**CANTERBURY EARTHQUAKE  
RECOVERY AUTHORITY**

**ACCESSIBILITY AUDIT  
VICTORIA SQUARE  
AVON RIVER  
CHRISTCHURCH**

**EXISTING SQUARE  
SITE AUDIT**

### 7.13.1 SEATING GENERAL

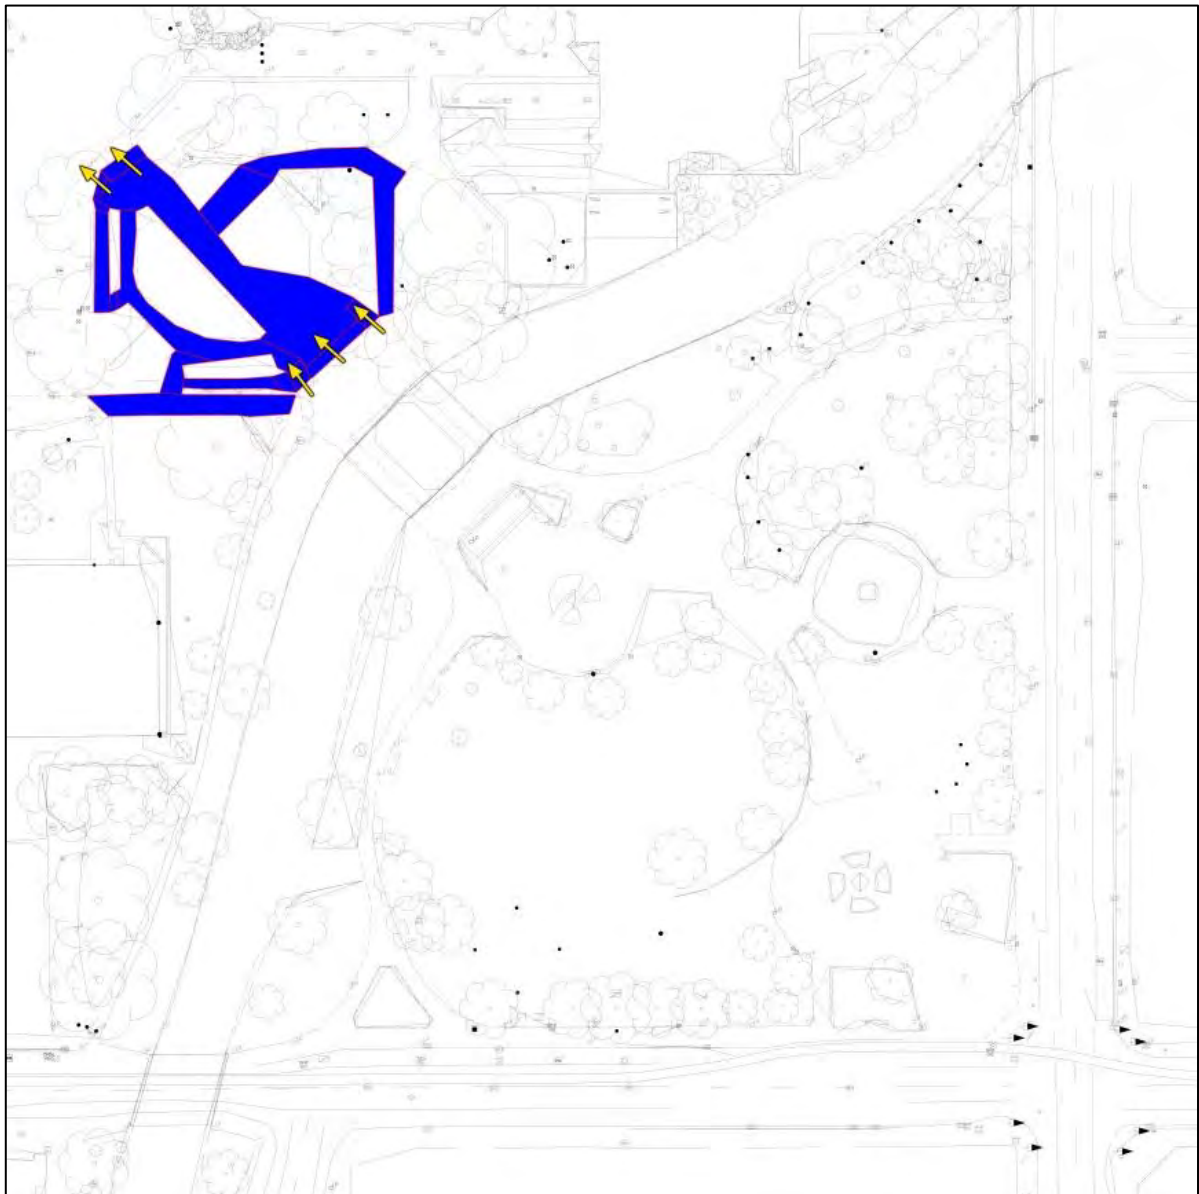
- The seating typically is of a curved bucket type throughout the park. The low point of the bucket is located at the rear of the seat and measures 410mm above ground level, with the high point at its front lip measuring 440mm above ground level. This low height, and deep bucket fixed seating may prove difficult for the elderly or persons with limited strength/mobility to sit in and get back up
- Where the seating is provided no clear bays or recessed areas are present, which means a safe level platform outside of the pedestrian flow for wheelchair users, persons with mobility aides and parents with strollers is not available.

- Seating should be provided to accommodate all persons regardless of ability. For elderly people the preferred seat height is 520mm, for children and small people the preferred seat height is 350mm, and for general use a seat height of between 400-450mm is preferred. Typically seating should be mixed height in each location it is placed to cater for mixed groups of people to sit together.
- Consider the inclusion of wheelchair, and stroller spaces between seating or to the side of it
- Replace the existing seating with seating that aligns as closely as possible to the dimensions given in NZS4121:2001 13.5.1, 13.5.2, Fig.49 and fig.50

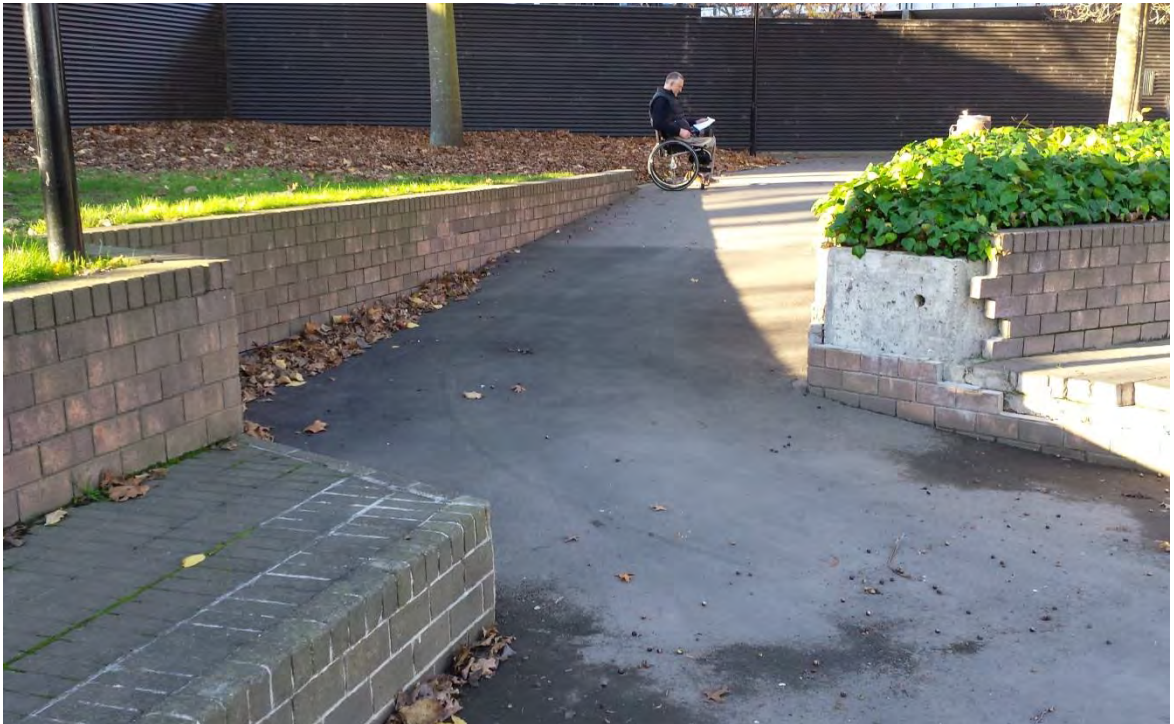
- The width of this pathway was 700mm wide at its narrowest point (between the bin and tree).
- The path has a steep traverse slope batter to the north.

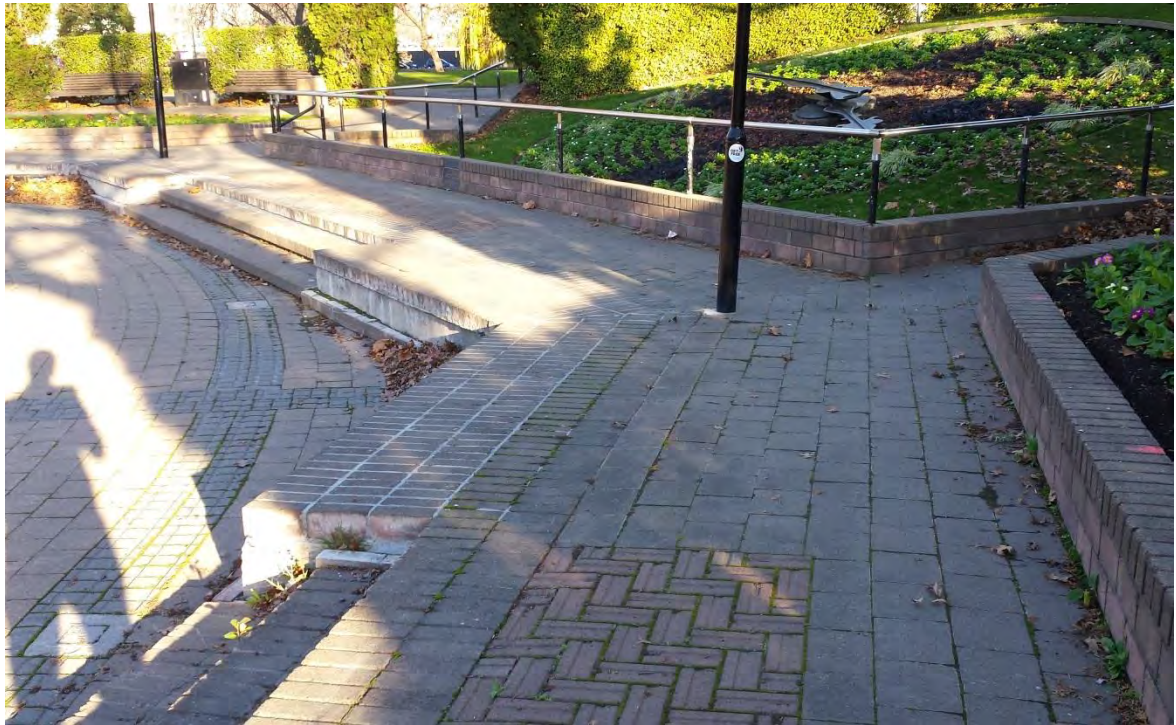
- There are some drop-offs and stairs around the edge of this path which are poorly contrasted to their surrounds.
